WALKERVILLE TERRACE DEVELOPMENT

PROJECT ADDRESS:
1 WALKERVILLE TERRACE GILBERTON SA 5081

PROJECT STATUS:
PLANNING

A1.01 ODASA FEEDBACK

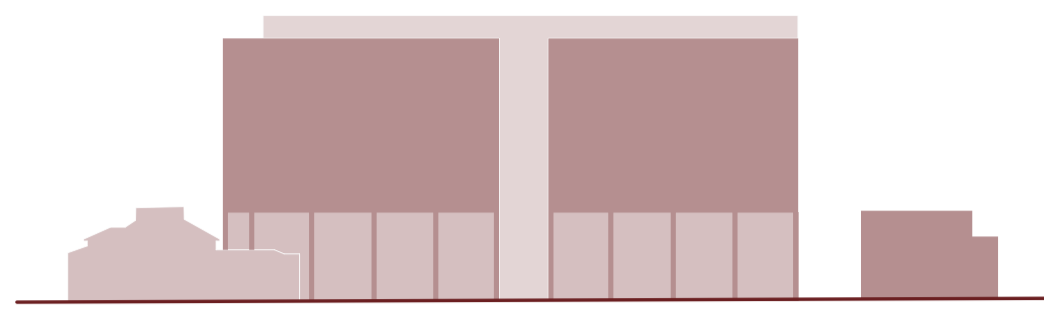
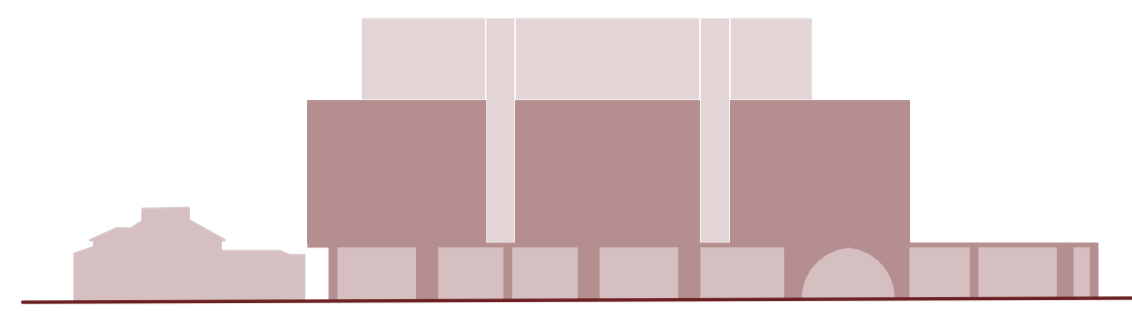
REFUSAL REASON
8. The proposal does not meet Performance Outcome 12.1 as the building does not positively contribute to the character of the local area by responding to local context as a result of the building massing, bulk and streetscape presentation.

DESIGN RESPONSE
LOCAL CONTEXT
With a diverse range of styles in the surrounding context, the proposal drawing on the heavy two storey mass to tie into the local context as well as warmer tones to be sympathetic to the adjacent built form.

VOID INCREASED IN SIZE

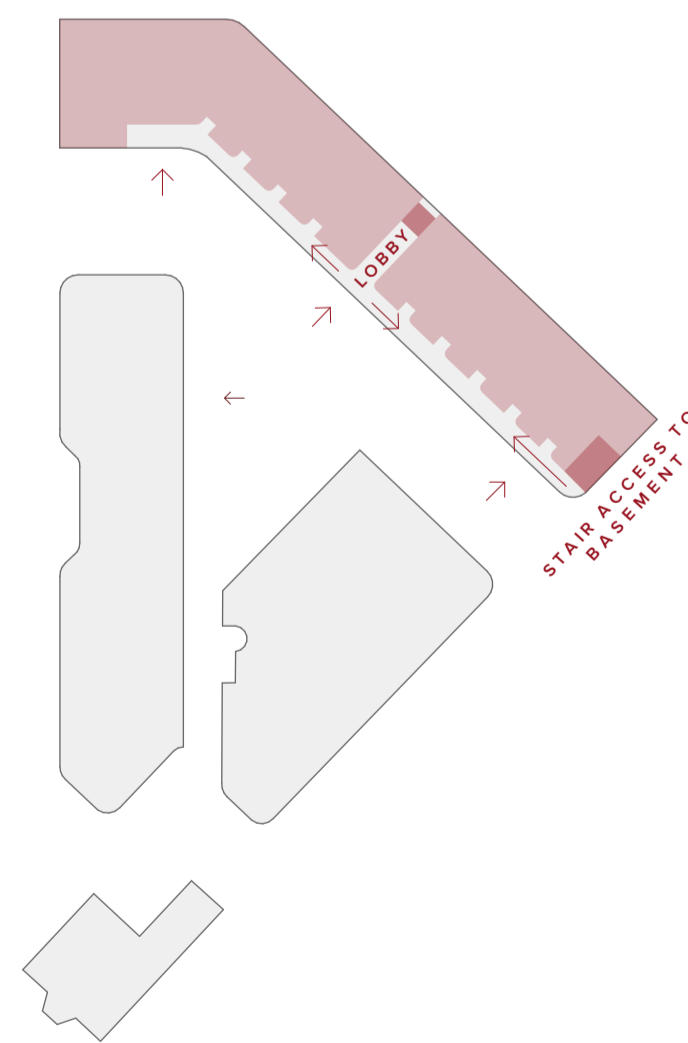
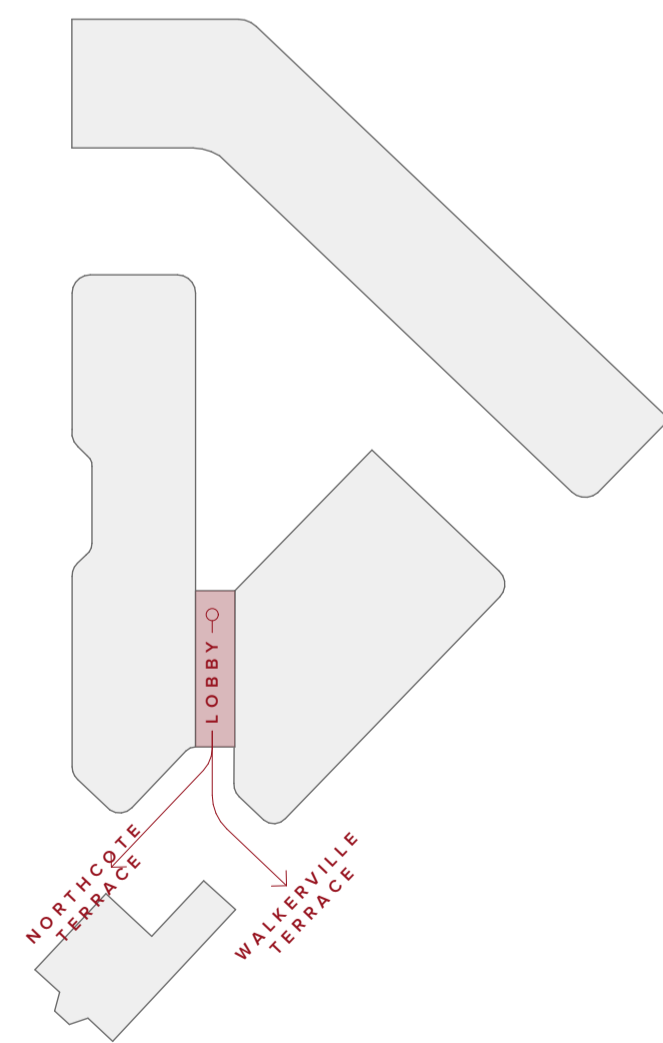
COMMENT
Concerns regarding the depth of soffits over the serviced accommodation balconies.

The central void size increased significantly to improve the natural light offering to the ground floor.

SECTION DETAIL (APT. 2B_3)

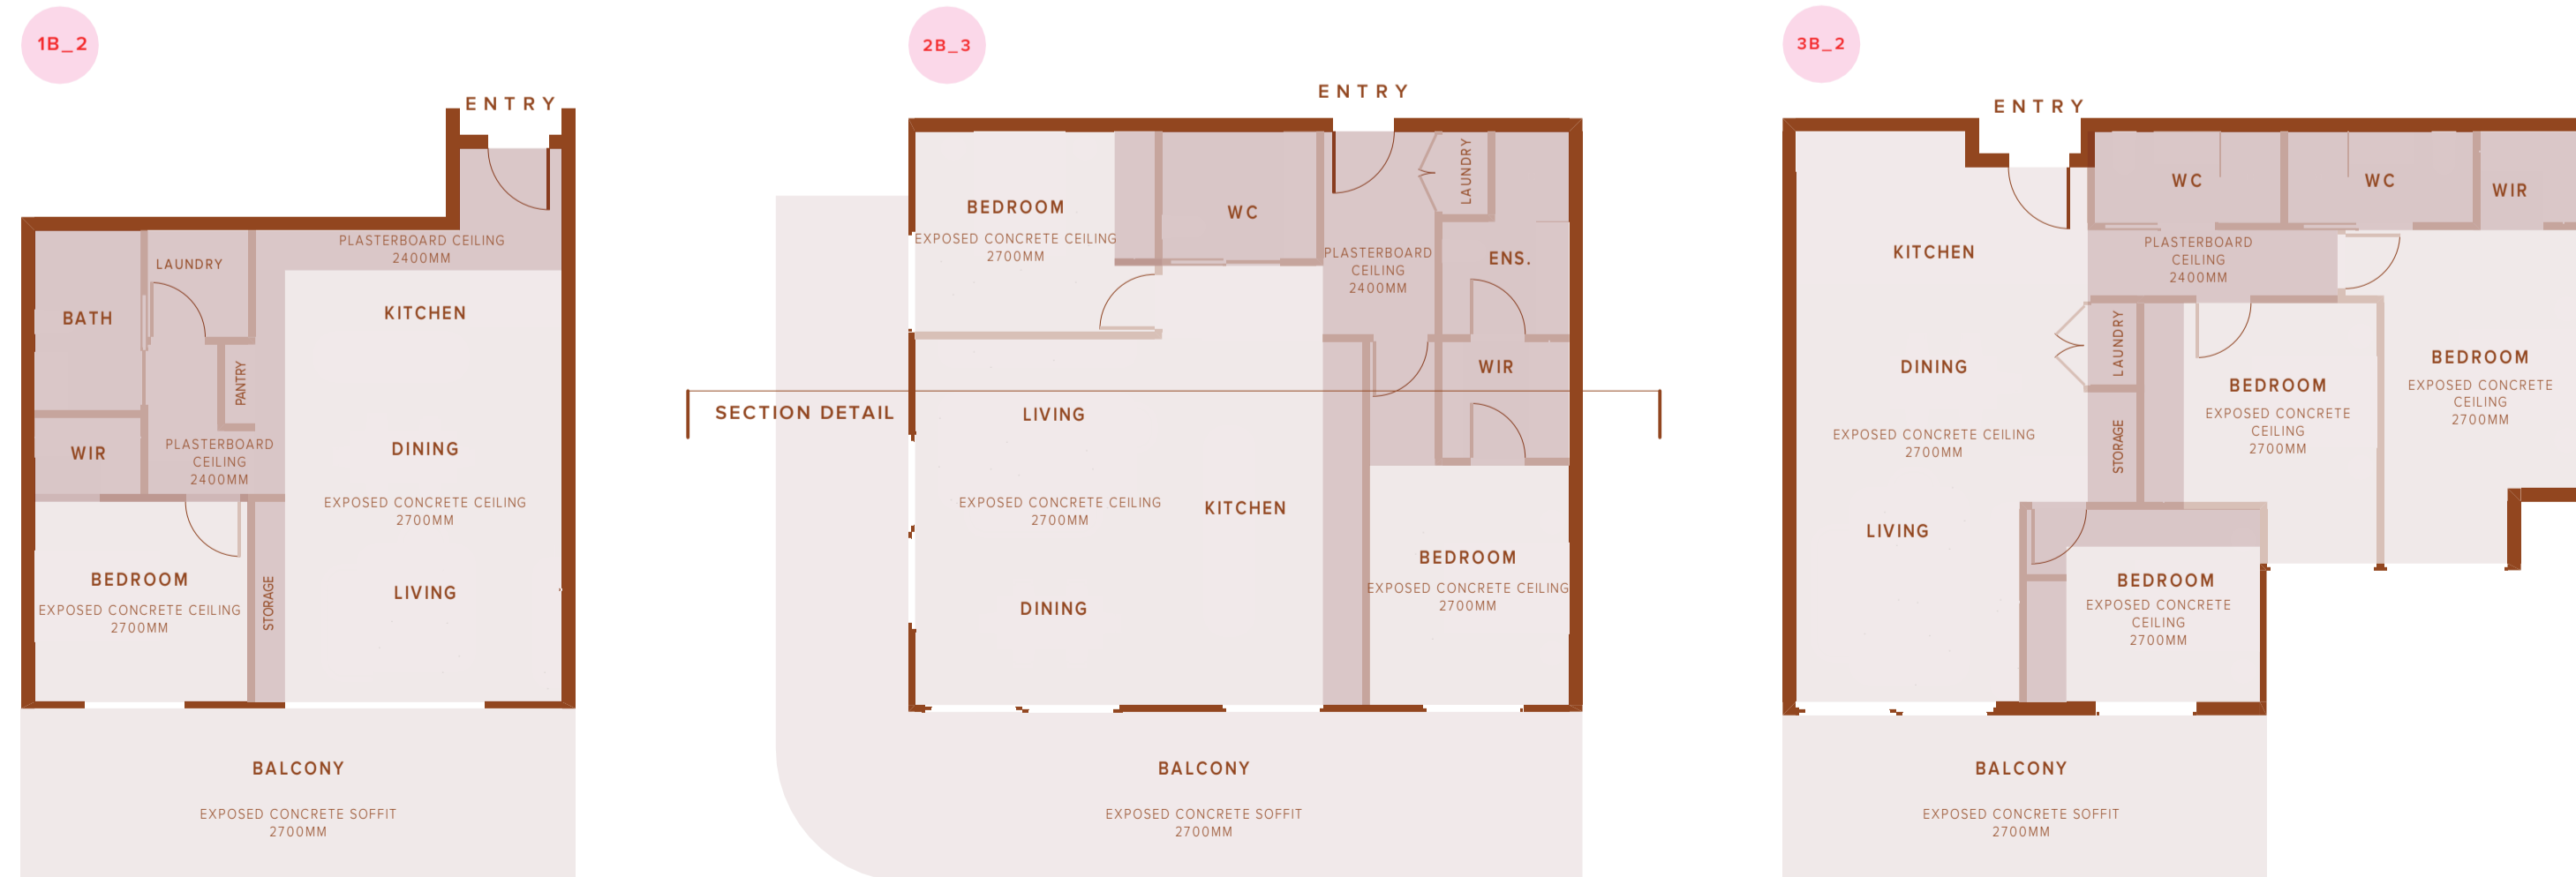
- To clarify the ceiling heights proposed throughout the apartments, ceiling plan diagrams have been incorporated. All living spaces and bedrooms will have a ceiling height of 2700 at a minimum. Maintaining this will be a priority as the design is refined.
Amended Drawings
A3.11 APARTMENT CONCEPT DETAIL

TYPICAL APARTMENT CEILING HEIGHT DIAGRAMS

EXPOSED CONCRETE CEILING WITH PLASTERBOARD BULKHEADS AND CEILINGS OVER CORRIDORS AND BATHROOMS
